SAFETY EVALUATION BY THE OFFICE OF NUCLEAR REACTOR REGULATION

SUPPORTING AMENDMENT NO. 75 TO PROVISIONAL OPERATING LICENSE NO. DPR-29

AMENDMENT NO. 68 TO FACILITY OPERATING LICENSE NO. DPR-30

QUAD CITIES STATION UNIT NOS. 1 AND 2

FIGURE 1- CROSSTIE OF RHR SERVICE WATER SYSTEMS

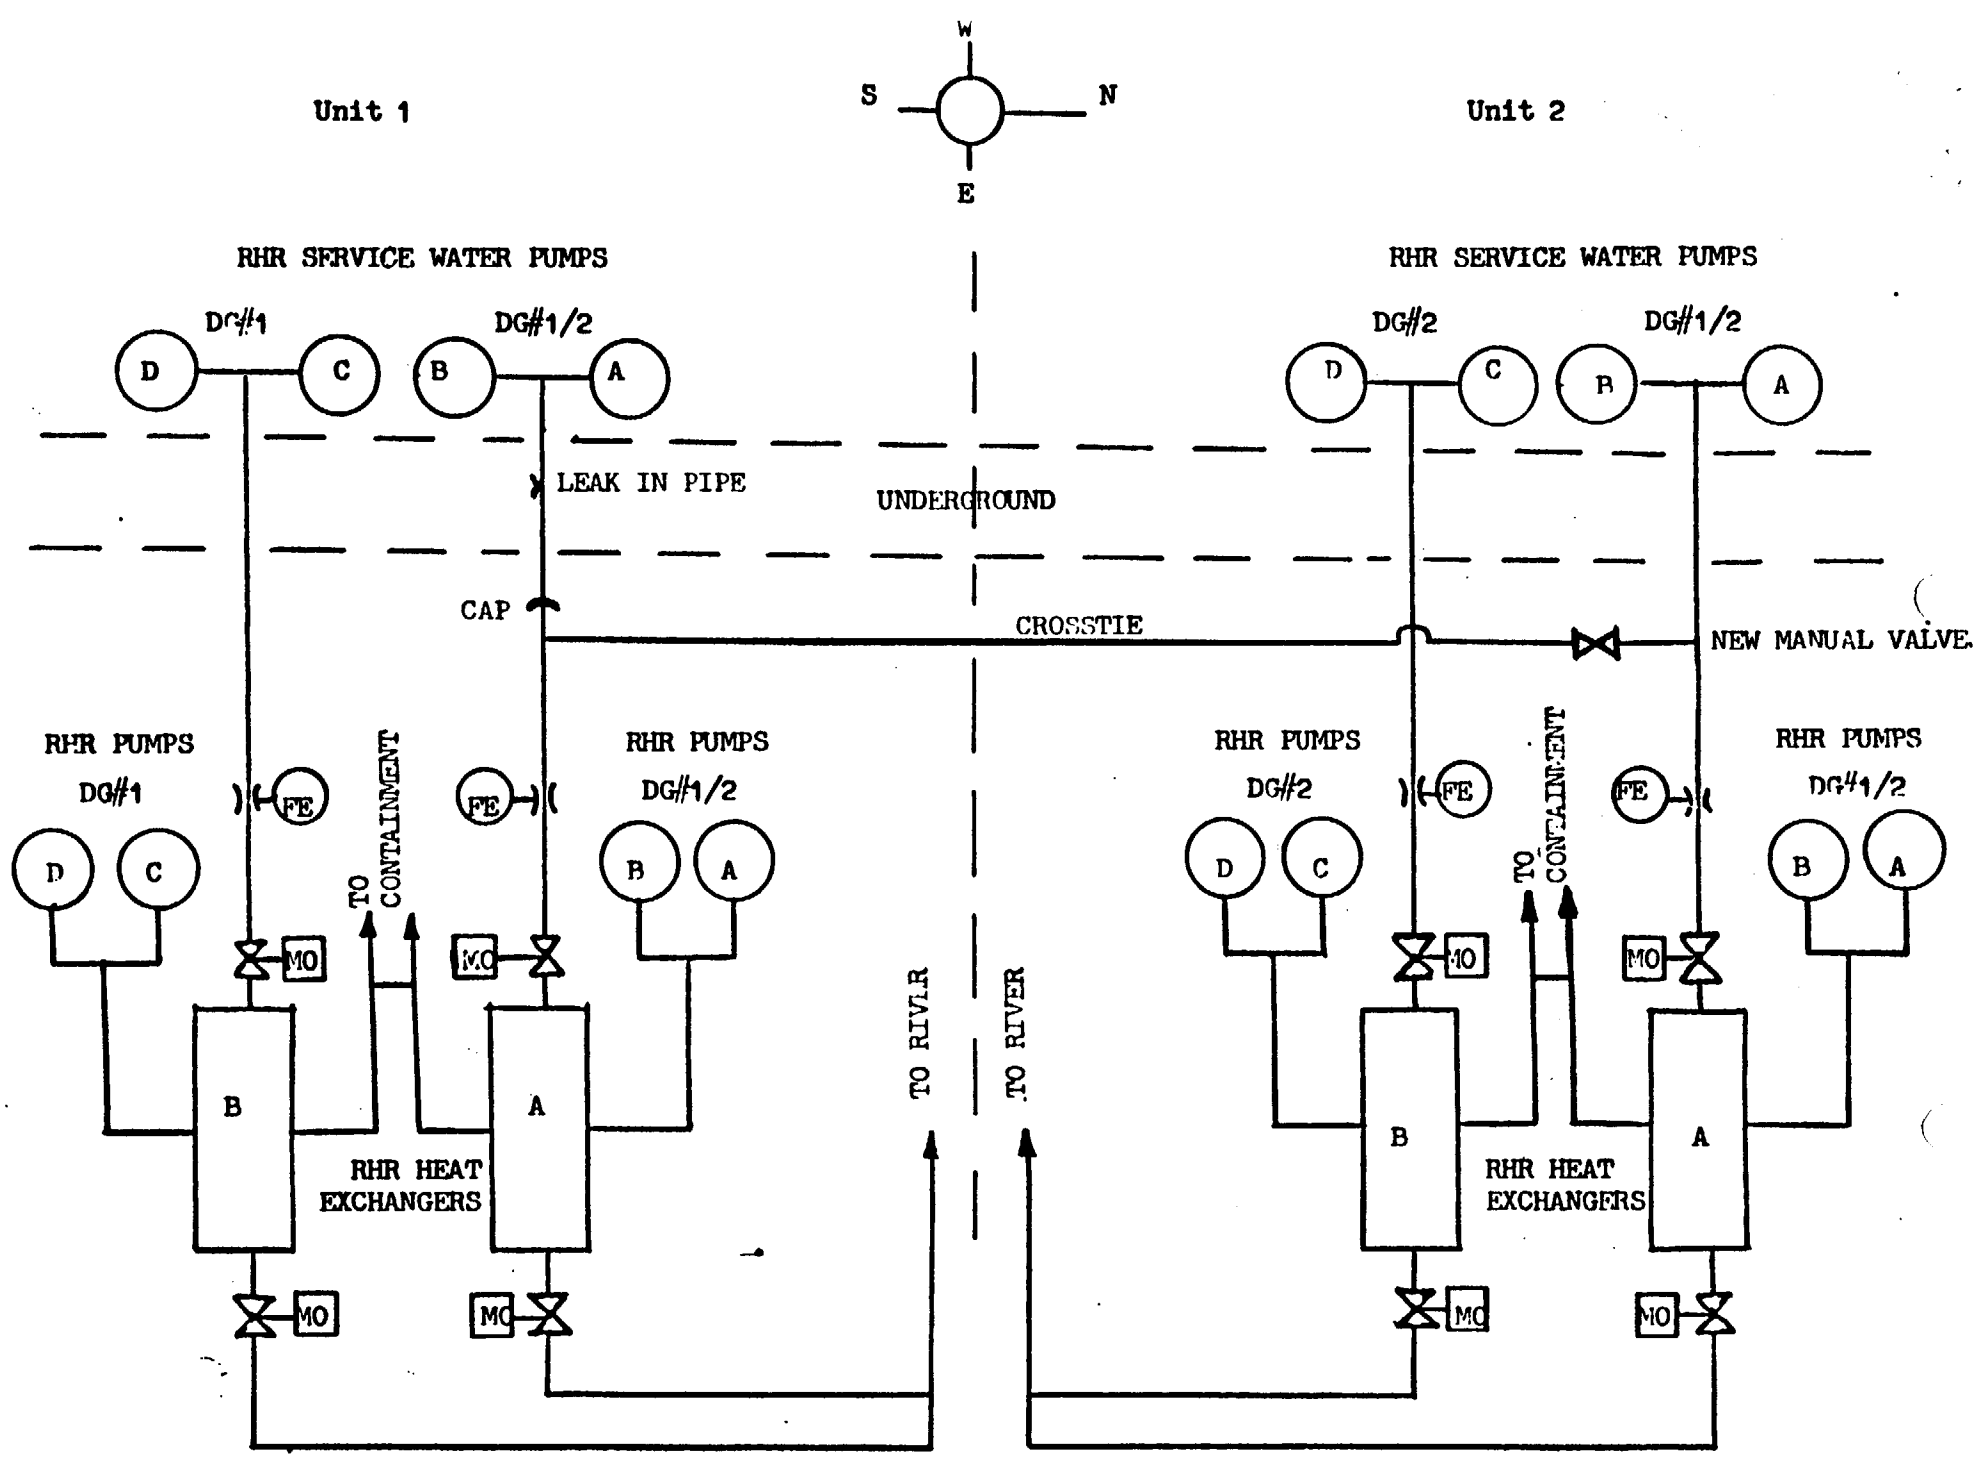
The containment cooling mode of the RHR system for each unit consists of two loops as shown in Figure 1. Each loop consists of one heat exchanger, two RHR pumps, associated valves, piping, electrical equipment and instrumentation. The "B" loop on each unit contains two RHR service water pumps. Normally the "A" loop on each unit also contains two RHR service water pumps. However, during the time interval from November 24, 1981 to June 1, 1982 the "A" loop on each unit may utilize the "A" and "B" RHR service water pumps from Unit 2. Service water from Unit 2 to Unit 1 will be delivered via the cross-tie line. Loss of one loop of the containment cooling mode of the RHR system leaves the remaining loop to perform the containment cooling function. Either loop of the RHR system can satisfy the containment cooling function.

As stated in the Quad Cities FSAR, only one RHR and one RHR service water pump are required to provide containment cooling following a loss-of-coolant accident (LOCA) on one unit. One RHR and one RHR service water pump are also adequate to place and maintain the other unit in the cold shutdown condition. Adequate containment cooling is therefore available in the event of a design basis LOCA concurrent with a loss of offsite power (LOOP) and the worst single failure, if one RHR and one RHR service water pump are available. If the Unit 1/2 (swing) D/G or Unit 2 D/G is postulated as the single failure, along with a Loss of Offsite Power, the modification results in no change to existing procedures or to the existing design basis. If the Unit 1 D/G is postulated to fail, the original design basis is met with the proposed changes since procedure changes and electrical modifications have been proposed to assure that adequate power is allocated to the necessary equipment during a Loss of Offsite Power.

We find this temporary modification acceptable because the licensee states and we concur based upon information elicited from the licensee that: (1) there is ample time, and there will be appropriate procedures and operator training to manually actuate the local switches to initiate the containment cooling function after an event; (2) the RHR containment cooling mode was always designed as a manual action; (3) no originally designed automatic protective features will be adversely affected; and (4) there will be no compromises to core cooling by this temporary modification.

FIGURE 2 SINGLE LINE DIAGRAM  
EMERGENCY POWER SYSTEM

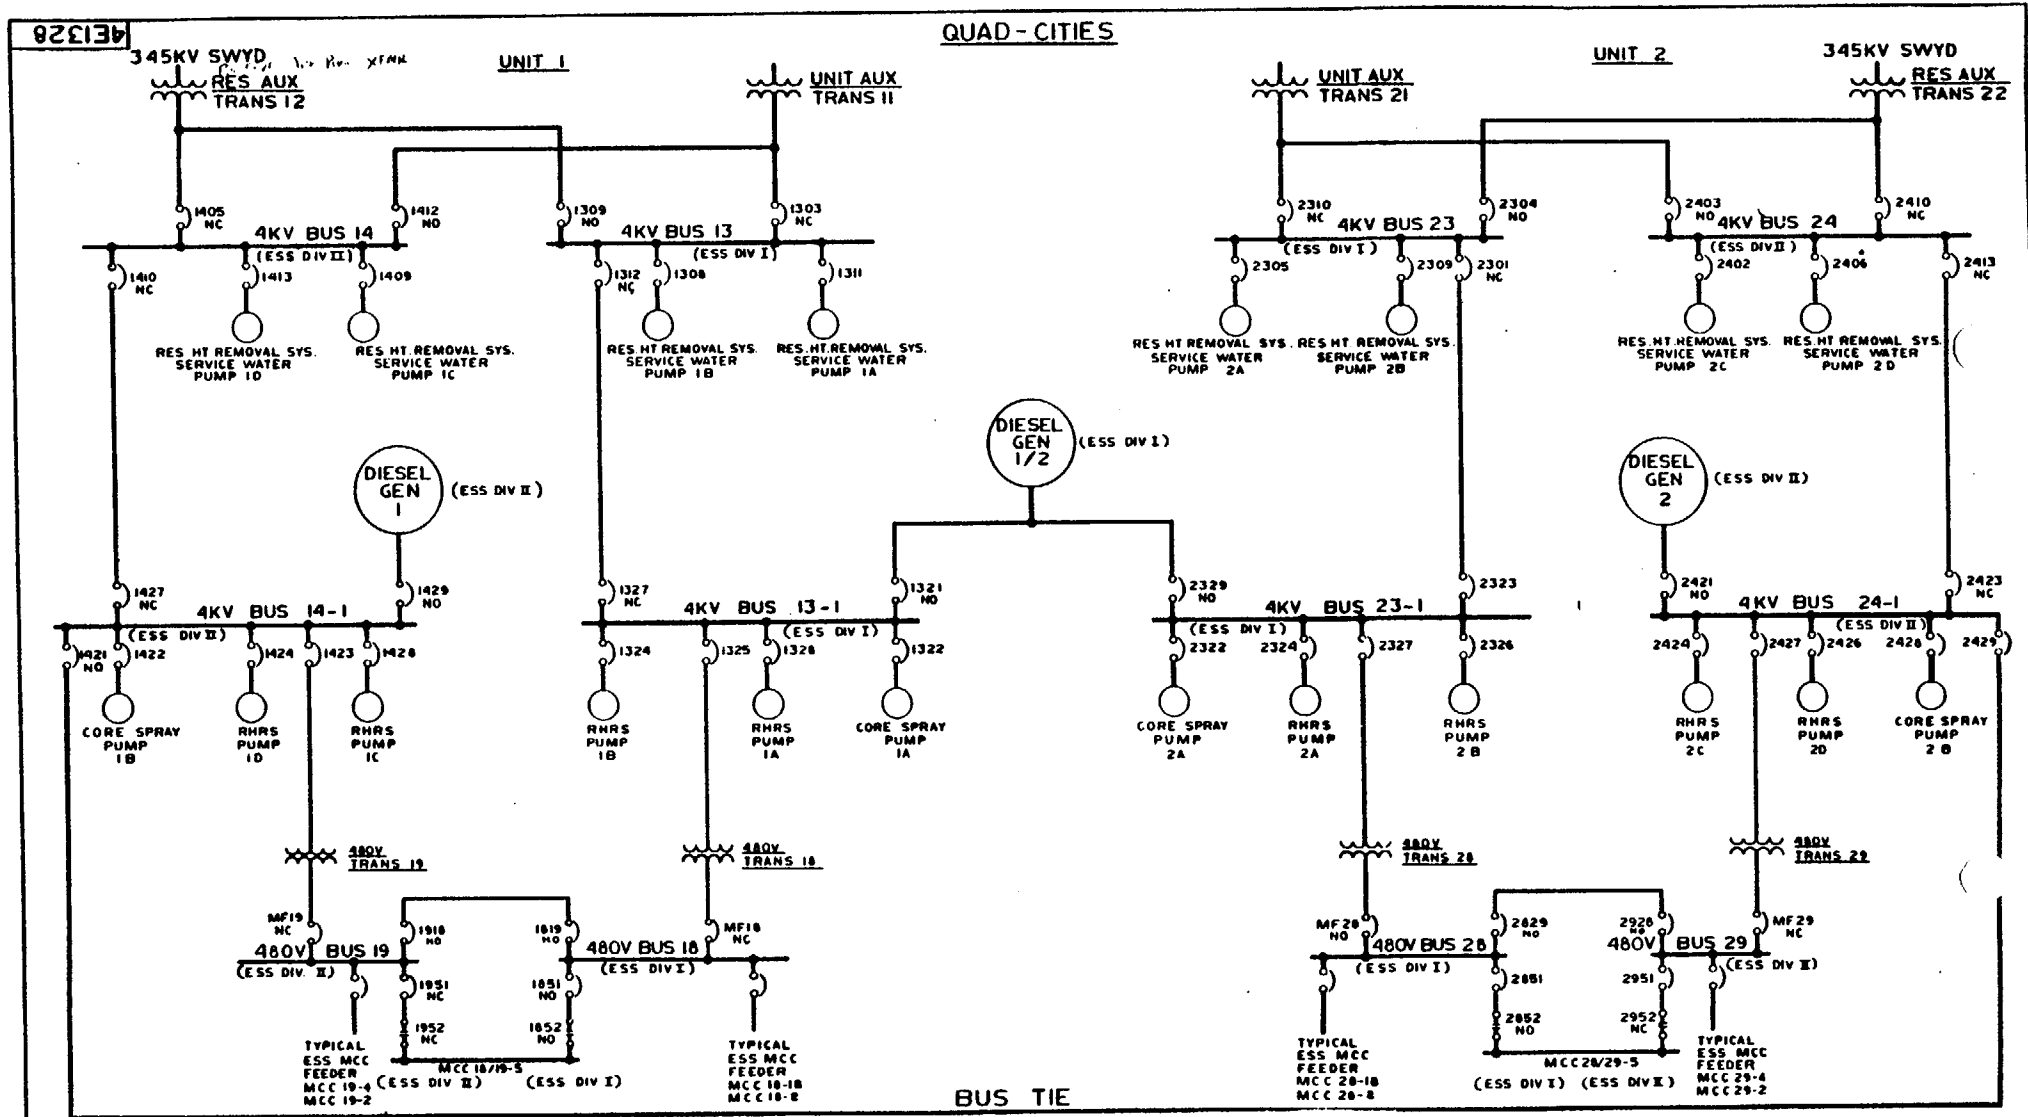
A procedure will be implemented which will allow Buses 13-1 and 23-1 to be energized by D/G 1/2 at the same time (see Figure 2). This will permit one Unit 2 RHR service water pump and one Unit 1 RHR pump to be powered by the D/G 1/2. This procedure would require that the ECCS pumps on Bus 23-1 be pulled-to-lock (prevented from auto starting) prior to closing two locally mounted control switches (as described below) which permit both buses to be energized by the 1/2 diesel.

To permit 1/2 D/G to supply Bus 13-1 on Unit 1 and Bus 23-1 on Unit 2 at the same time, a breaker position interlock in the closing circuit of either one of the two 1/2 DG output breakers must be bypassed when the redundant breaker is already closed. This action is accomplished in either 1/2 DG output breaker by means of a control switch which is physically and electrically independent of its redundant counterpart. Once the breaker position interlock is bypassed in the 1/2 DG output breaker that is open, the operator will then be able to close this output breaker from the control room.

To minimize the probability of operator errors that will leave the bypass control switches in the wrong position, after their function was accomplished, the licensee was advised that we will require that the bypass condition in each breaker closing circuit be automatically removed when the associated 1/2 DG output breaker is opened. The licensee has elected to implement this requirement by providing bypass control switches that are spring-return-to-open. This in essence, automatically removes the bypass as soon as the operator releases the switch from the bypass position. We find this to be an acceptable way to implement our requirement in this regard. The licensee has also stated that the bypass control switches will be of the same type as those previously qualified and presently used in existing safety related circuits in the plant.

The licensee stated that the modification will be fully tested to assure that the 1/2 diesel can energize Bus 23-1 when it is already energizing Bus 13-1, or energize Bus 13-1 when it is already energizing Bus 23-1. It will also be demonstrated that the closing circuits will revert to the original condition when the bypasses are removed.

Prior to this modification implementation, the licensee has committed to write procedures and train operators in the use of this new installation.
